Volume II
of the
Final EIS/EIR for the
Van Ness Avenue BRT Project

Appendices I & J

Response to Comments

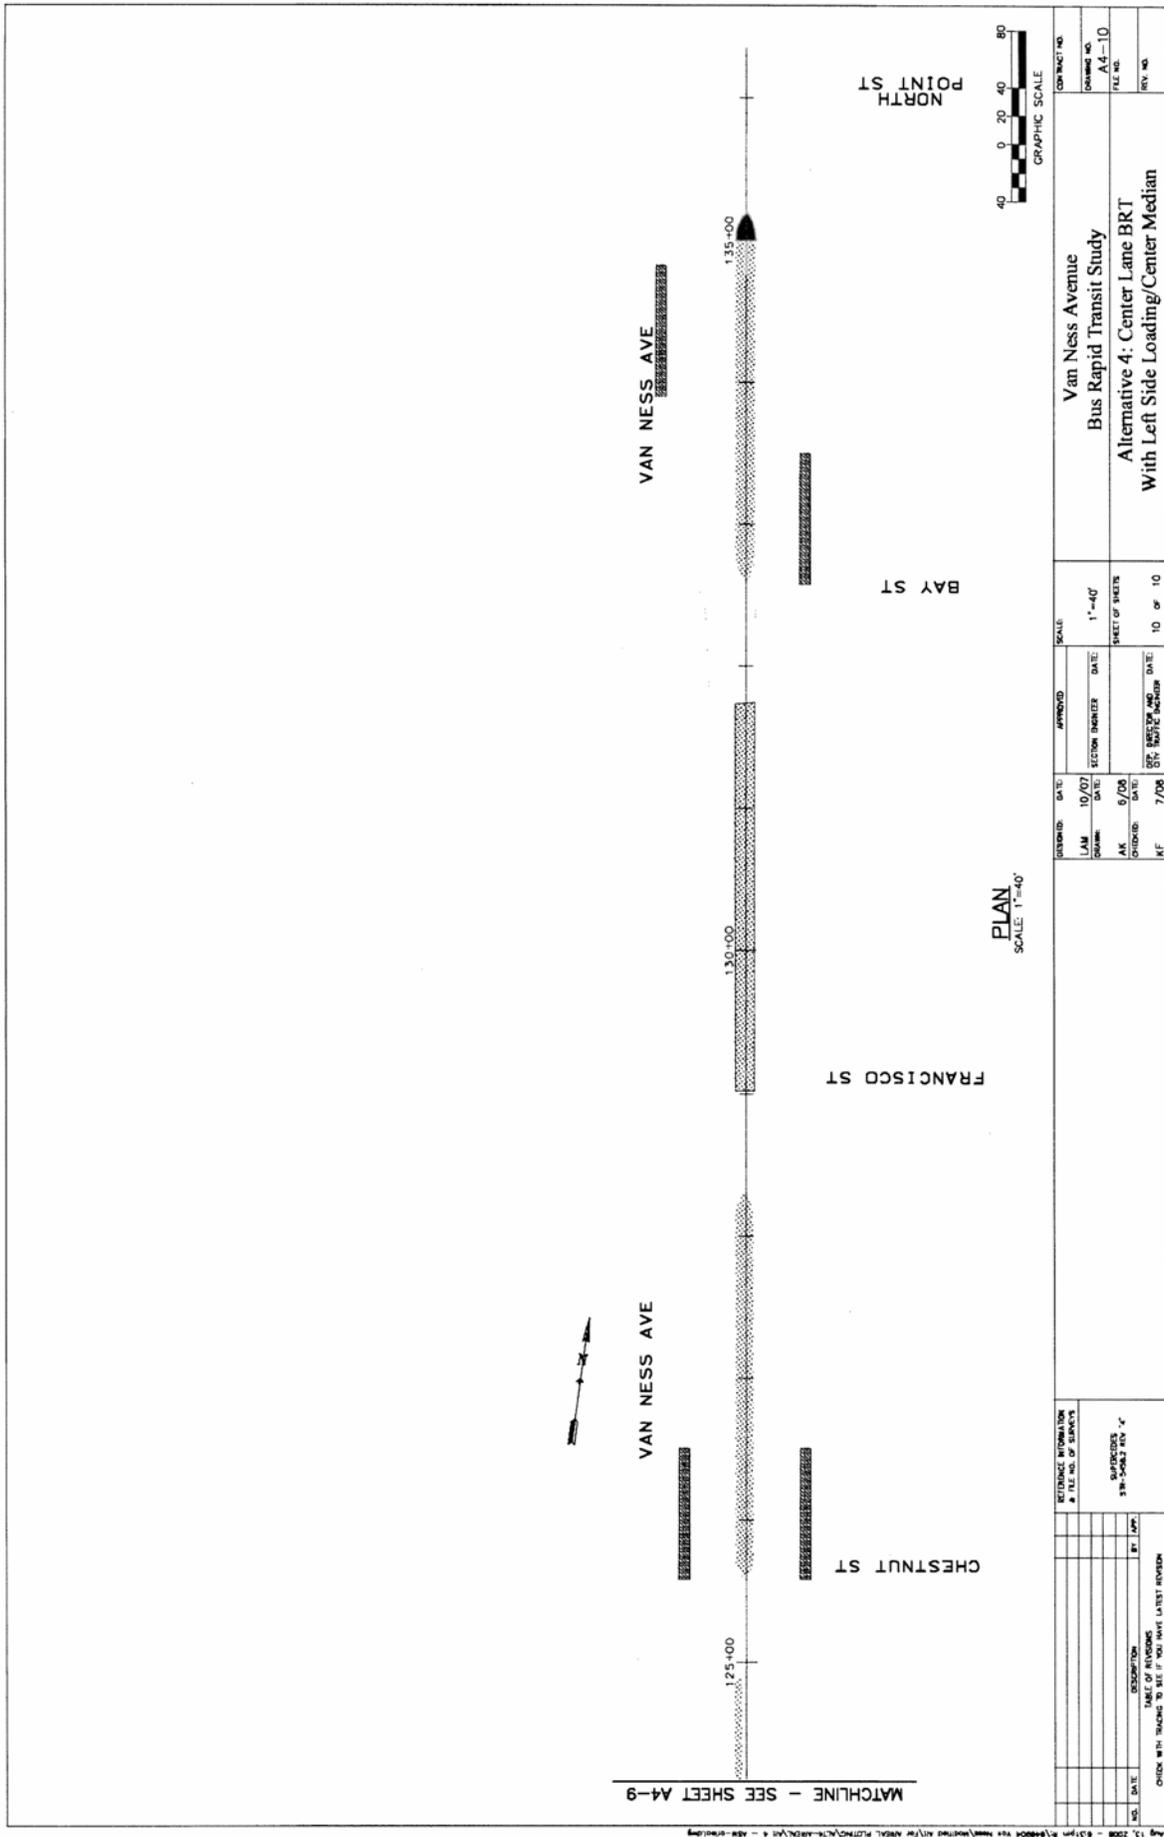
HP HYDRANT TO BE
RELOCATED TO 37' OF
NEW CURB

FIT BRASS CISTERNE RING

HP HYDRANT TO BE
RELOCATED TO 27"
FROM NEW CURB

F/S BRICK CISTERNA RING
